Official Transcript of Proceedings
NUCLEAR REGULATORY COMMISSION

Title: Advisory Committee on Reactor Safeguards
Fukushima Subcommittee: Open Session

Date: Wednesday, September 5, 2012

FUKUSHIMA SUBCOMMITTEE

Core debris flow to Suppression Pool

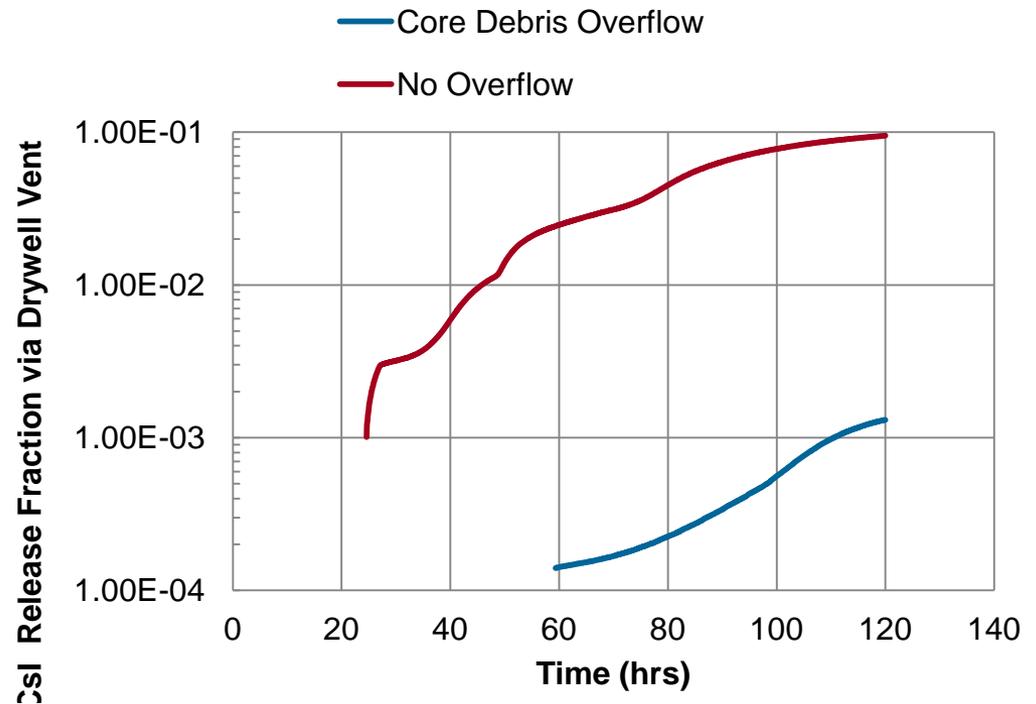
2 Left and right, all we are showing here
3 are two of the five sites that have MARK II plants.
4 There is a single site that looks like the one on the
5 right, where what I call the pedestal region below the
6 drywell is actually filled solid with concrete. So,
7 any debris that would get down there, if not flooded
8 or cooled with sprays or injection, could have some
9 pretty prolonged core-concrete interaction, where the
10 one on the left, which is the majority of the
11 remaining MARK IIs, any debris that gets down, either
12 through the pedestal or through the drywell, is likely
13 going to find its way into water, which is normally
14 considered to be a good outcome.

20 But it depends on the plant. They are all
21 unique, but they all tend to have some form of
22 equipment or a sump drain under the reactor vessel, if
23 not one, maybe two. And it is typically a 4-inch
24 pipe. It might be bolted up to the floor on a flange,
25 a 9-inch flange, or something. But it does

15 But, for our cases, we basically looked at
16 the plant as-is and the plant, and you will see in the
17 plots it says "bypass" or "no bypass", and you can see
18 the outcome, depending on what you assume on the
19 bypass. And again, we think there are mechanisms to
20 cool and protect at least the sump, the sump
21 drainline, that has already been employed at other
22 plants. I think Palisades had a modification made to
23 their cavity to do a similar thing. So, there are
24 ways to protect that, prevent the pool bypass.

Selected Results of MELCOR Calculations

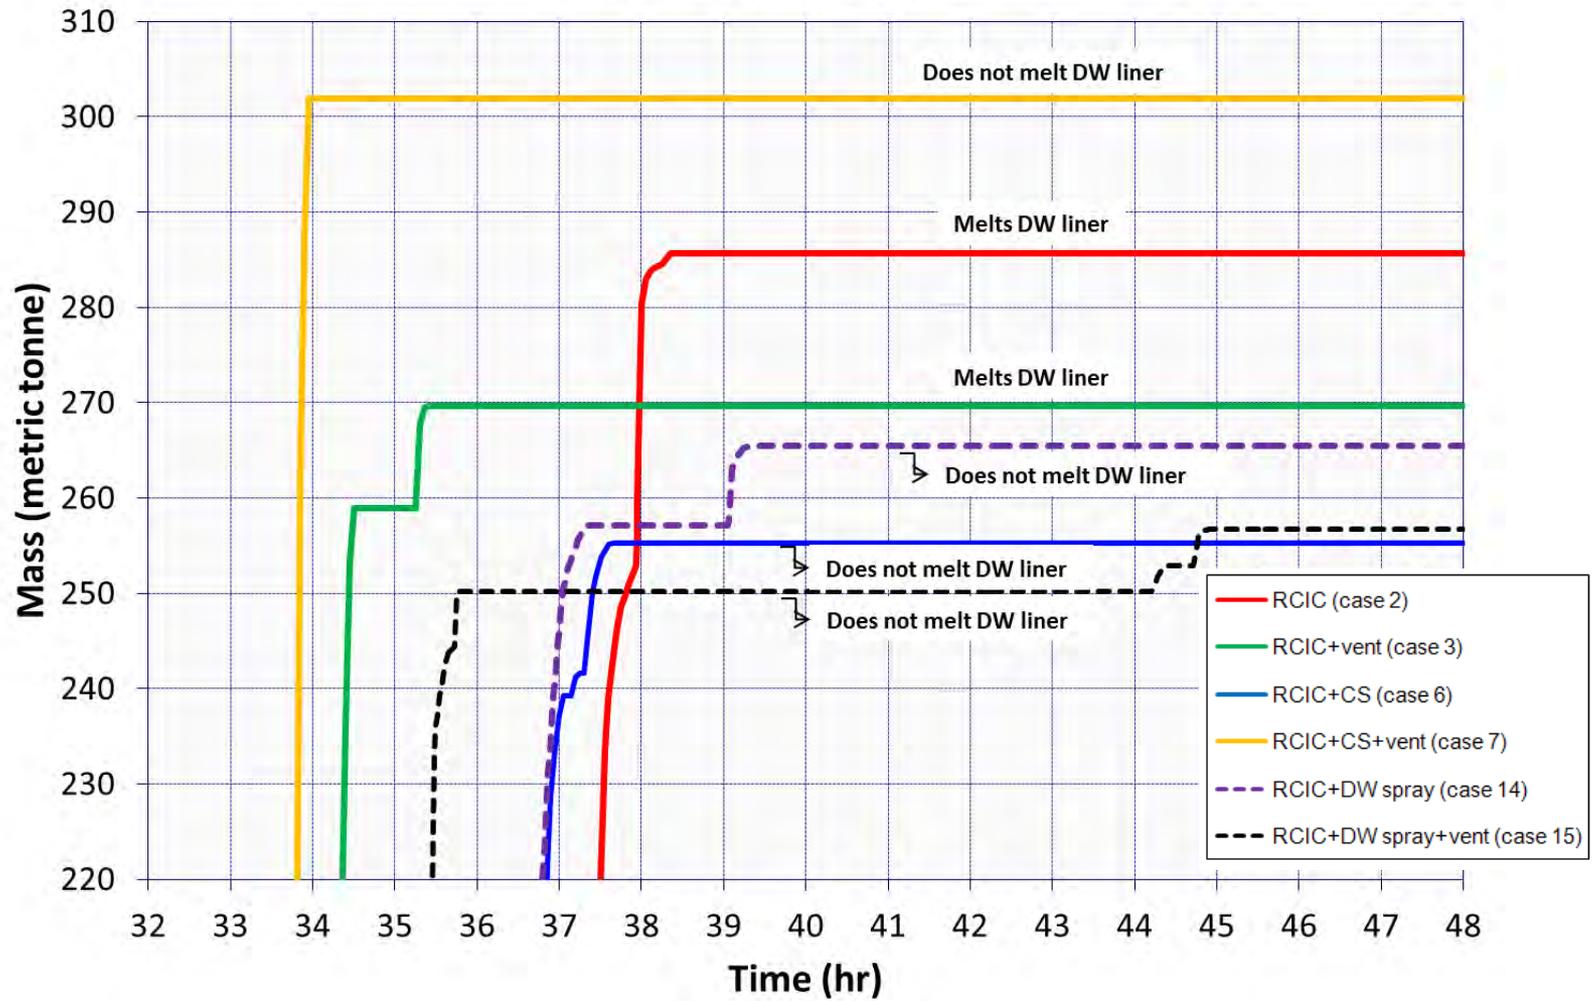
3 MEMBER REMPE: -- although maybe the
4 question will rise up in the plots, too. But it seems
5 like venting seems to increase in-vessel hydrogen
6 generation on this table, for like, if you look at the
7 difference between Case 2 and 3?

19 DR. BASU: And that is what we are looking
20 into now, why for the venting case. I don't have an
21 answer to that. I don't have an answer to it. We are
22 looking into it.

17 MEMBER STETKAR: I am way outside of my
18 knowledge level. But your observation, if I look at
19 1 versus 2 -- oh, I'm sorry -- 2 versus 3, 6 versus 7,
20 both of those show lower cesium releases if I vent.
21 I kind of understand why that is.

22 On the other hand, 14 and 15 show about a
23 factor of three times larger, if I look at your table,
24 cesium release fraction if I vent. Is there a
25 physical reason for that?

In-vessel Hydrogen Production (kg-mol)

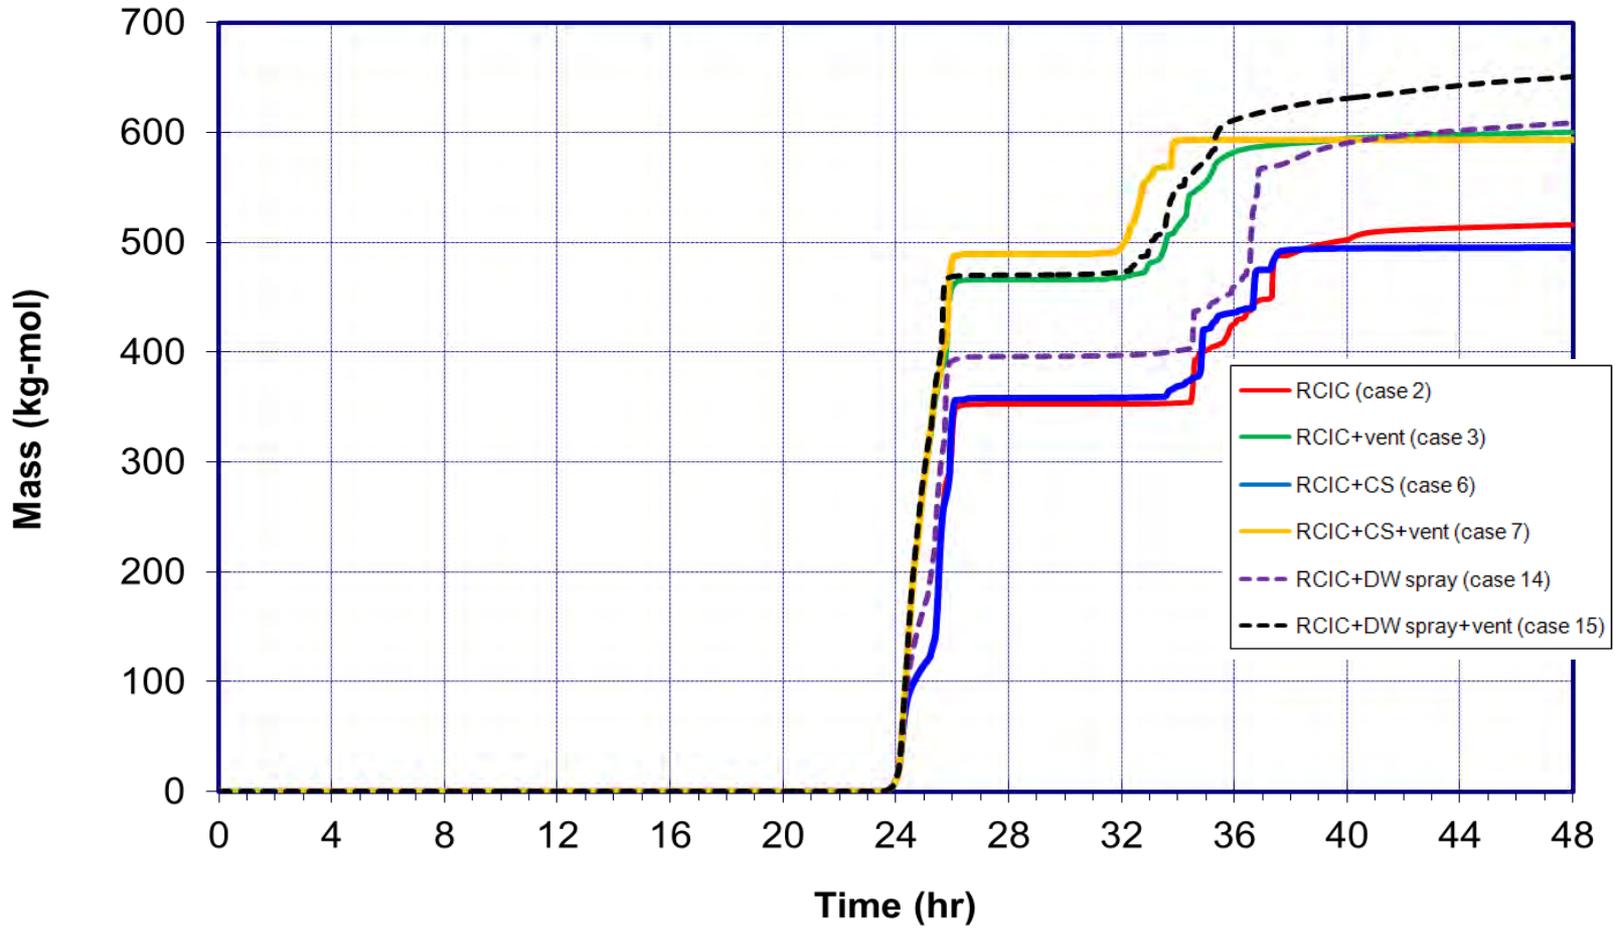
3 Okay. So, this is in-vessel hydrogen
4 production. We already had a question on that for
5 cases with venting. We will take that as an IOU; we
6 will get back to you.
